**Appendix F Response to Requests for Additional Information**

A large number of Requests for Additional Information (RAIs) were generated during the USNRC review of MUAP-07013. Table F-1 identifies the responses to questions.

- F-1. Letter, Y. Ogata (MHI) to J. Ciocco (USNRC), MHI's Partial Responses to the NRC's Requests for Additional Information on Topical Report MUAP-07013-P (R0) "Small Break LOCA Methodology for US-APWR", UAP-HF-09002, Mitsubishi Heavy Industries, Jan. 2009.

**Figure RAI-7-23.1 Hot Assembly Flowrate Oscillation during Boil-off Phase**

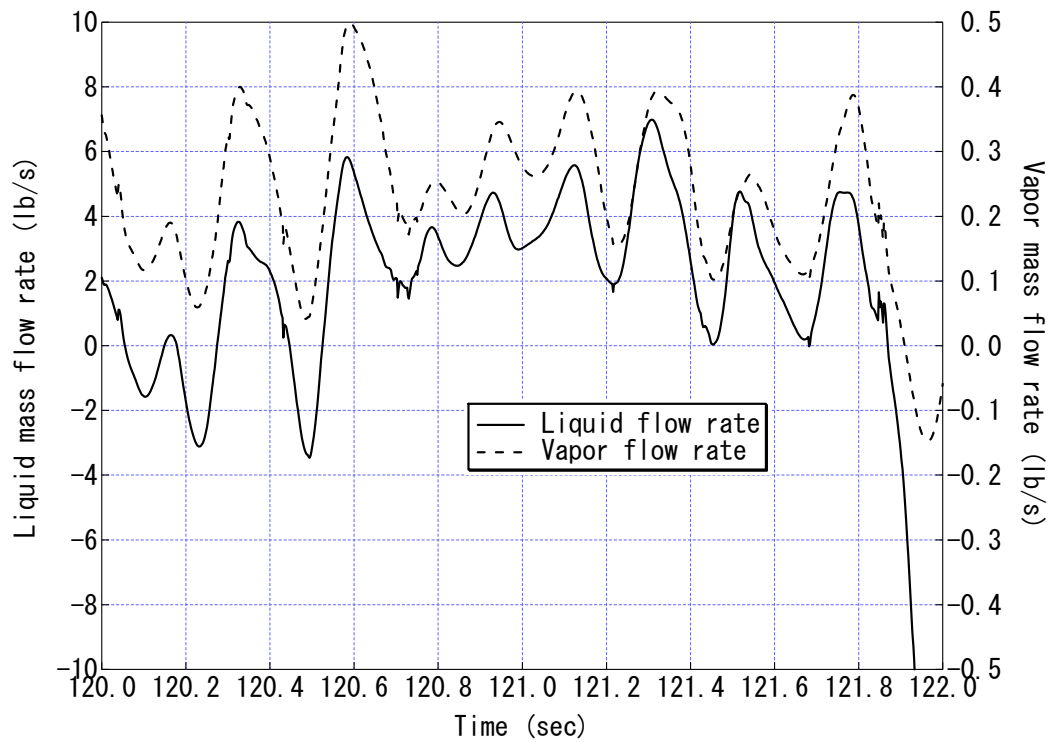
Fig RAI-7-14.15, 16 and especially 18 of the July response (UAP-HF-09362) show very large and rapid oscillations in the vessel, including the core, flows. This raises the question about whether these flow oscillations promote core cooling. Appendix K, Section C.7.a on Core Flow Distribution During Blowdown" requires that "The calculated flow shall be smoothed to eliminate any calculated rapid oscillations (period less than 0.1 seconds). Discuss the manner in which this Appendix K requirement is satisfied.

Figure 8.1.1-7.1 Sensitivity Calculation for Upper Plenum Flow Area

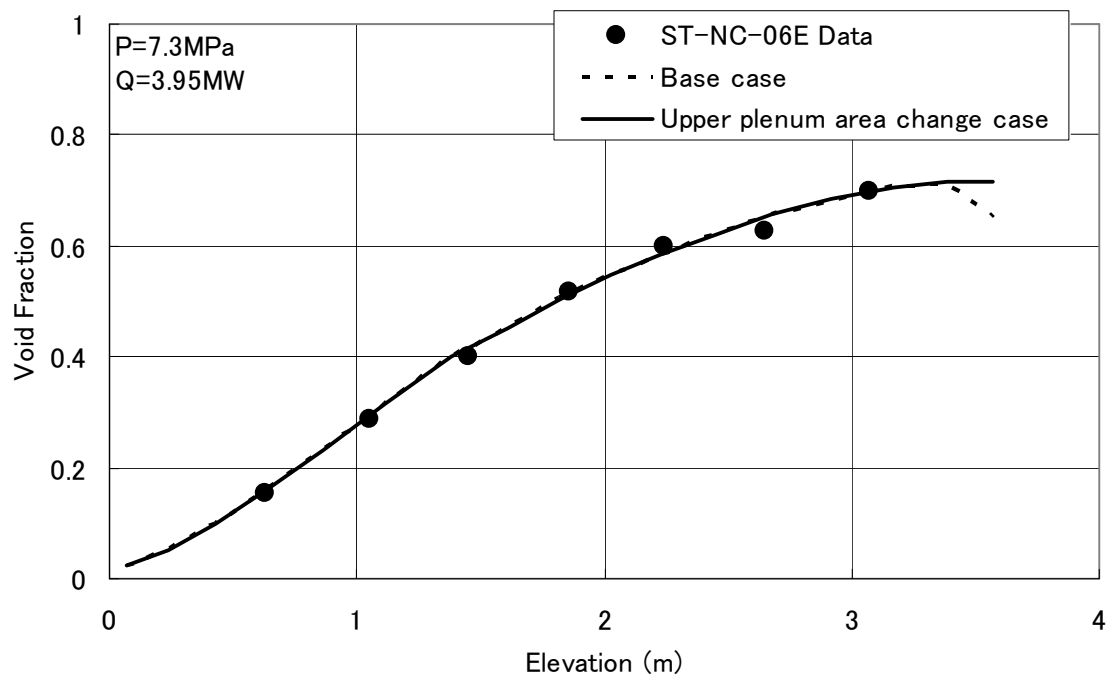
Figure 8.1.1-6 shows a comparison of the predicted and measured void fraction profiles. The void fraction decreases at the highest node in the M-RELAP5 prediction. One would expect the void fraction to continuously increase. Please explain this prediction.

A sensitivity calculation in which the flow area of the upper plenum node is changed to be identical to that of the core-heated section has additionally been performed. As shown in the Figure 8.1.1-7.1, the void fraction continuously increases in the sensitivity case, different from the base case.
